ADDENDUM NO. 2**BID NO. 19-07****MIDDLETON ROAD EXTENSION
CITY OF ABERDEEN, MARYLAND**

To all holders of the specifications, the following corrections are hereby made. All other items shall remain unchanged. This addendum shall become part of the Contract Documents for the above referenced project.

- **Section 1: Answers to Questions Posed by Bidders**
- **Section 2: Updated Bid Schedule**
- **Section 3: Crosswalk and Crosswalk Line Detail**
- **Section 4: Revised Construction Drawings**

Figure 3B-20a. Examples of Crosswalk and Crosswalk Lines

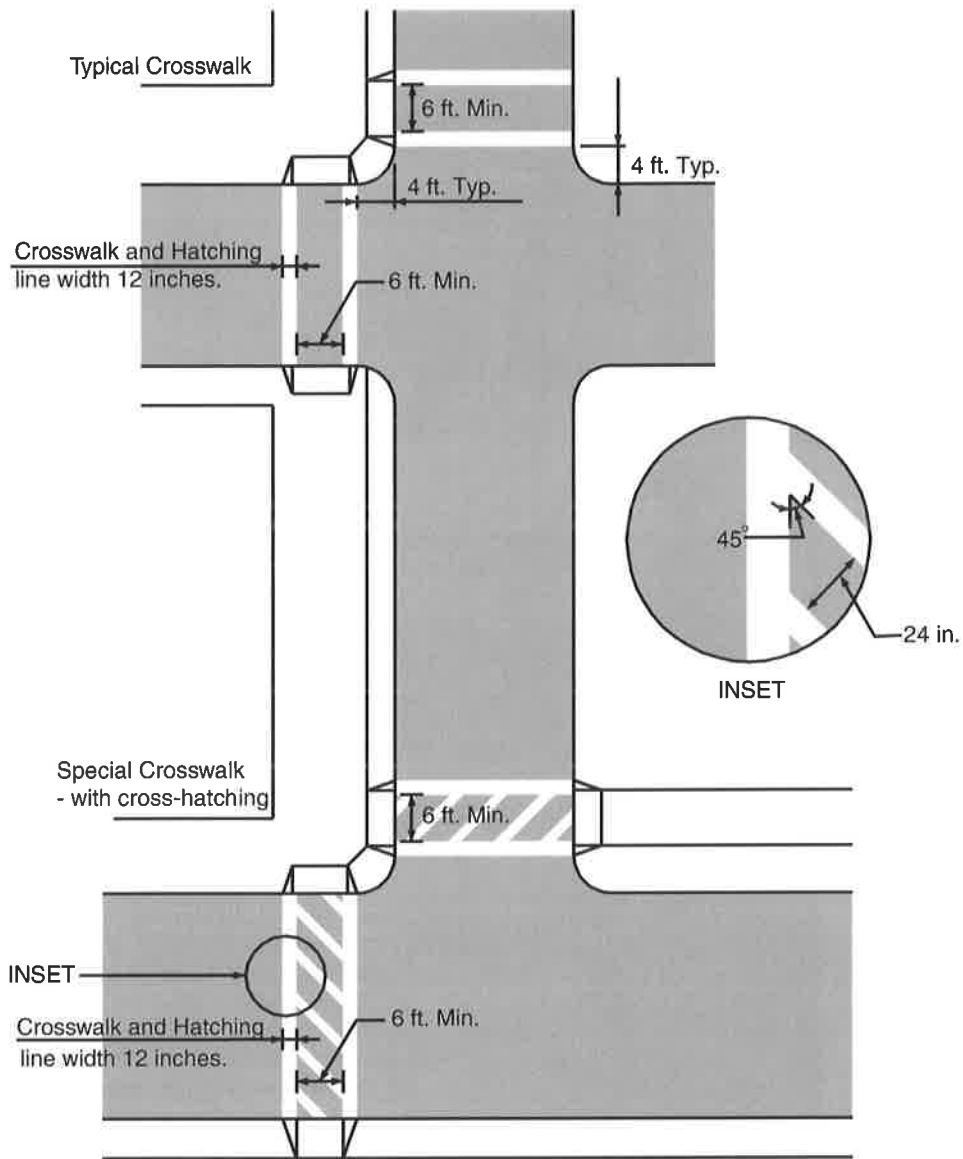
13	Handicap Curb Ramps	280	S.F.		
14	Pavement Marking, Double Yellow	1,400	L.F.		
15	Pavement-Marking, Crosswalk	4	EA		
16	Pavement-Marking, Solid White Line	3000	L.F.		
17	Street Trees Deciduous	26	EA		
18	Street Trees Evergreen	40	EA		
19	Sheet Aluminum Traffic Signs	63	S.F.		
20	Precast or Cast-in-place COG/COS Opening for 8" Curb 10' only	3	EA		
21	Class I Riprap	78	S.Y.		
22	8" Concrete Apron for Roundabout	2,000	S.F.		
23	Common Borrow	2,100	C.Y.		
24	Site Grading	1	L.S.		
25	Grass Swale	2,148	L.F.		
26	Culvert 1 (12" HDPE)	40	L.F.		
27	Standard Type C 345.01 for 12" HDPE	1	UNIT		
28	Standard Concrete End Section MD 368.01 for 12" HDPE	1	UNIT		
29	Culvert 2 (38"x24" ERCCP)	70	L.F.		
30	Standard Type C 355.02 for 38"x24" ERCCP	1	UNIT		
31	Standard Concrete End Section Elliptical Pipe MD 369.00 38"x24" ERCCP	1	UNIT		
32	Culvert 3 (22"x14" ERCCP)	110	L.F.		
33	Standard Type C 355.02 for 22"x14" ERCCP	1	UNIT

A35: Item #11 has changed to SY. Item #13 has been eliminated. Item #15 has been clarified and a detail provided. For the watermain, the type of pipe has been revised.

MIDDELTON ROAD EXTENSION
TITLE SHEET

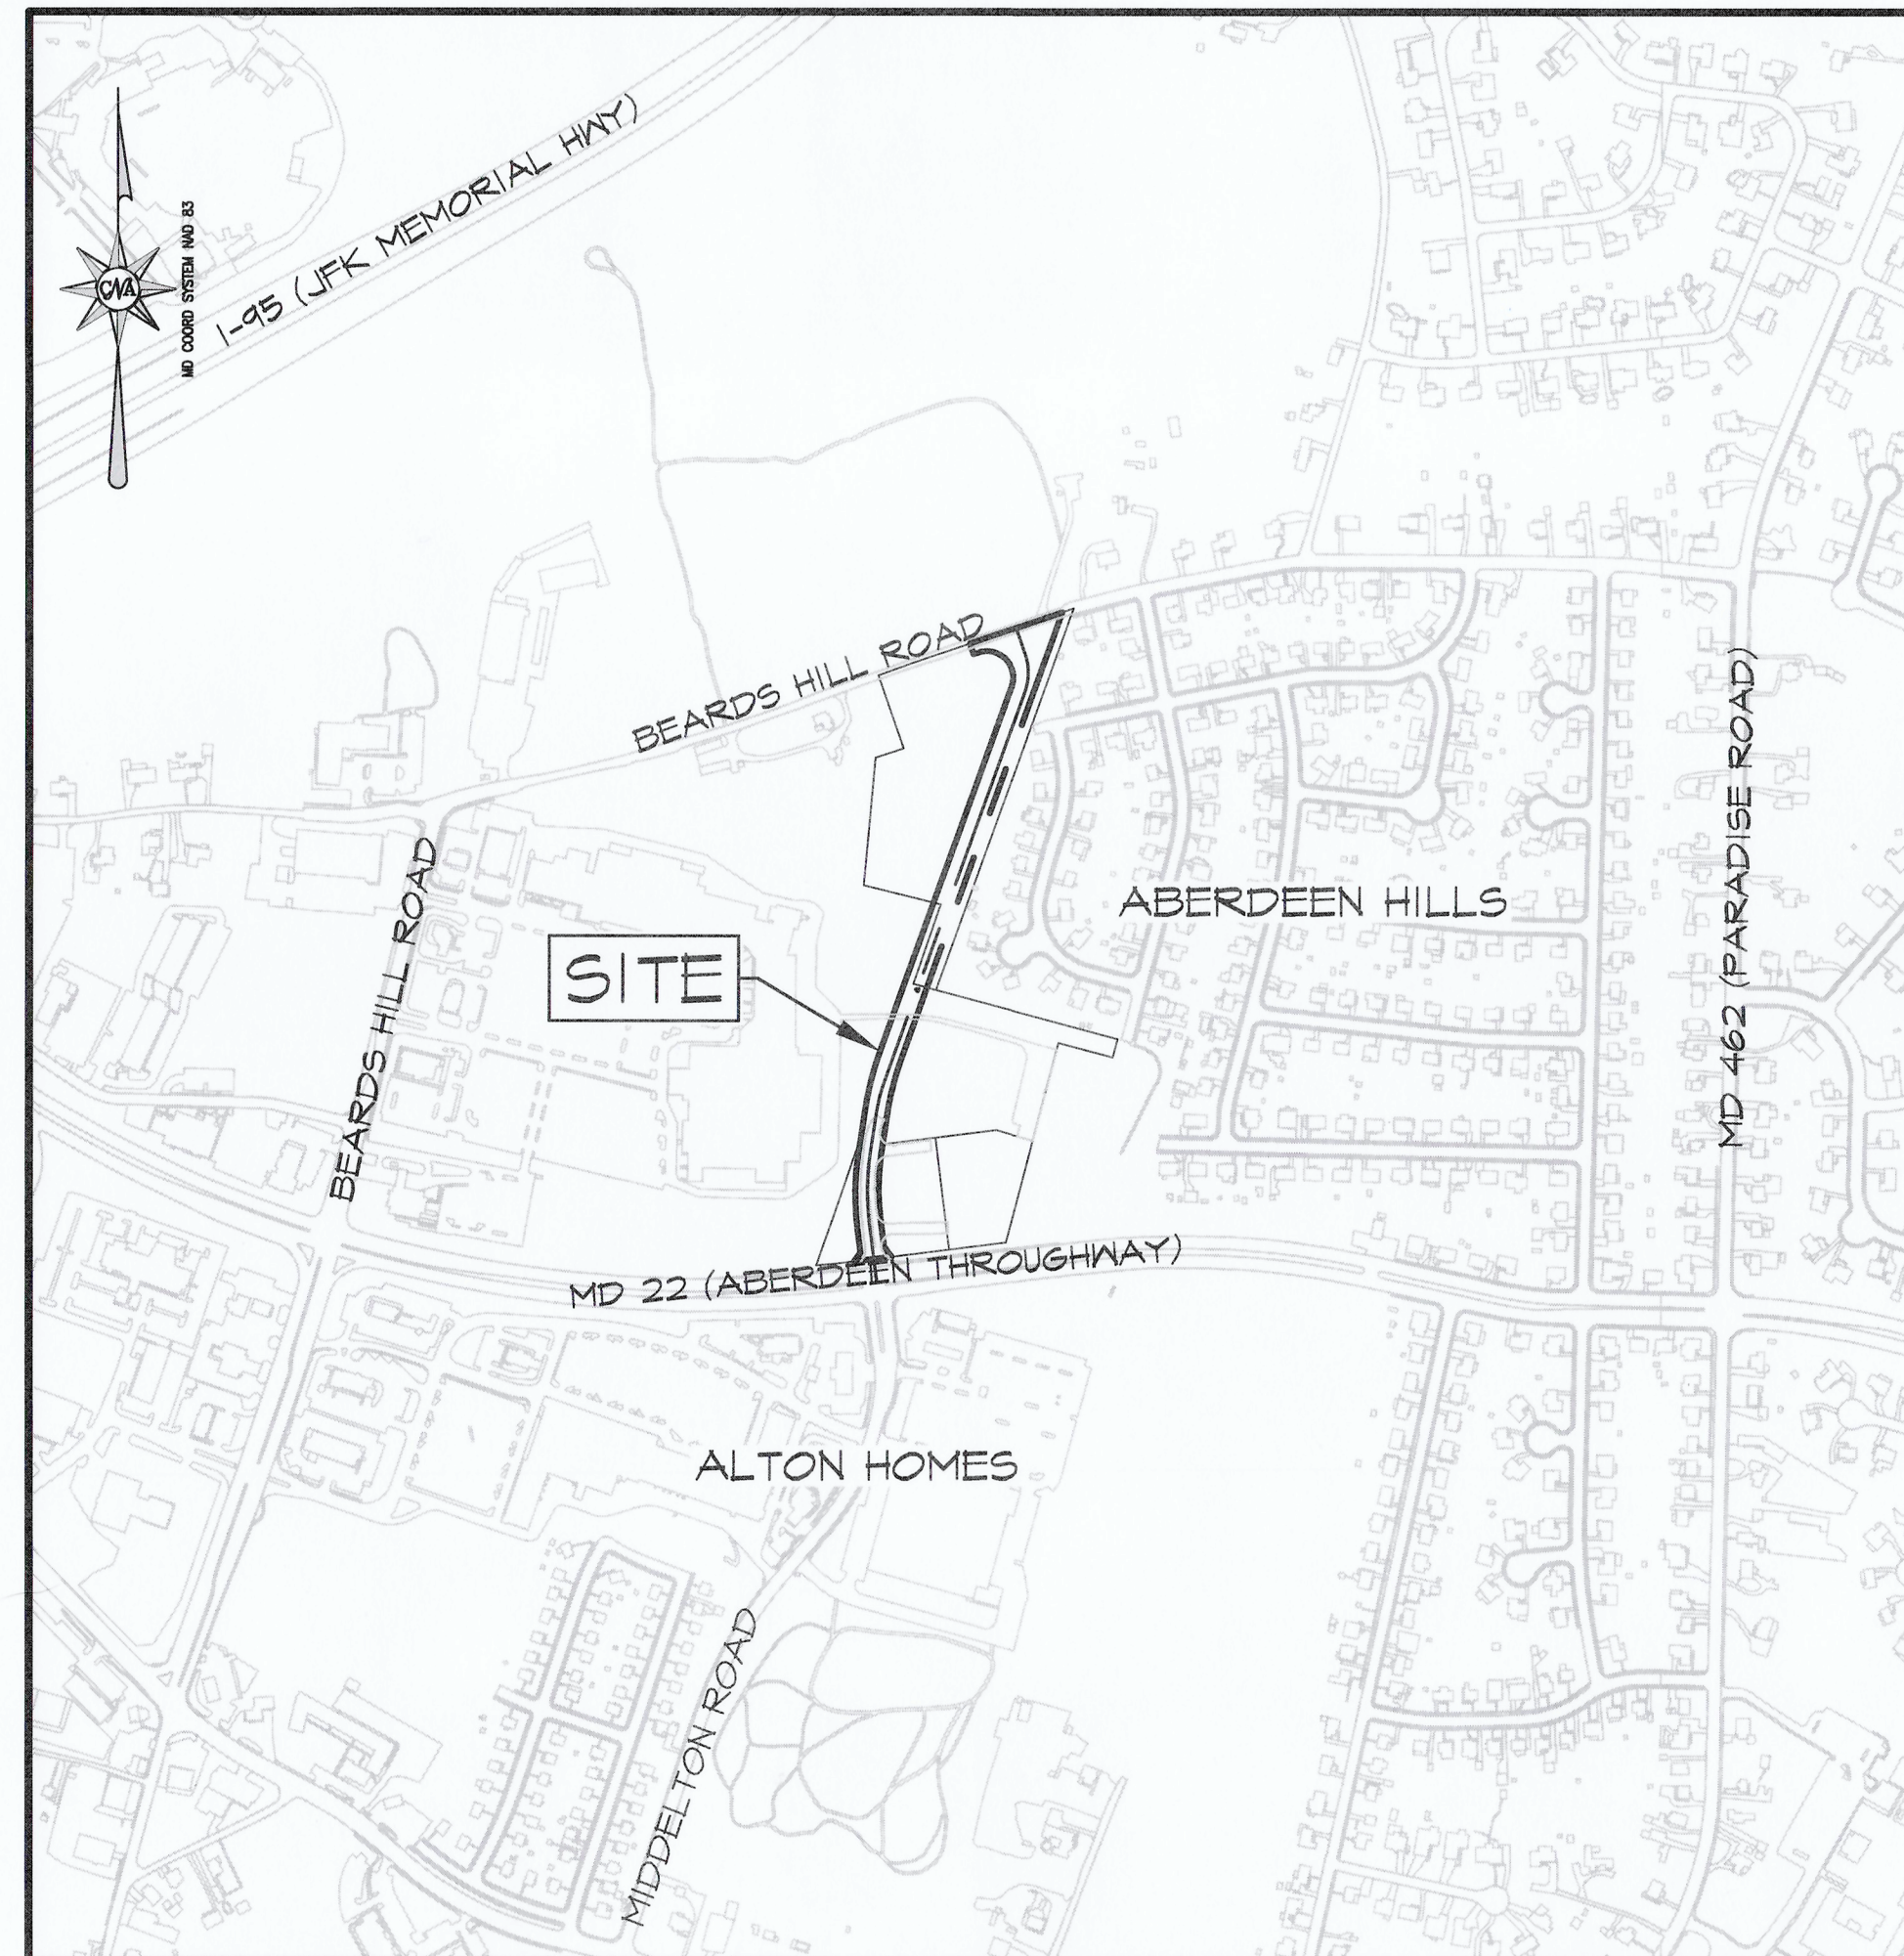
Q16: Sheet 1 Note 19 – Should it say "Contractor" and not "City or Contractor"?

Q22: Note 19 (Sheet 1 of 15) states that staking/surveying is the responsibility of the contractor or the owner. Please clarify who the responsible party will be.

A16: This is the Contractor's Responsibility.

A22: Contractor.
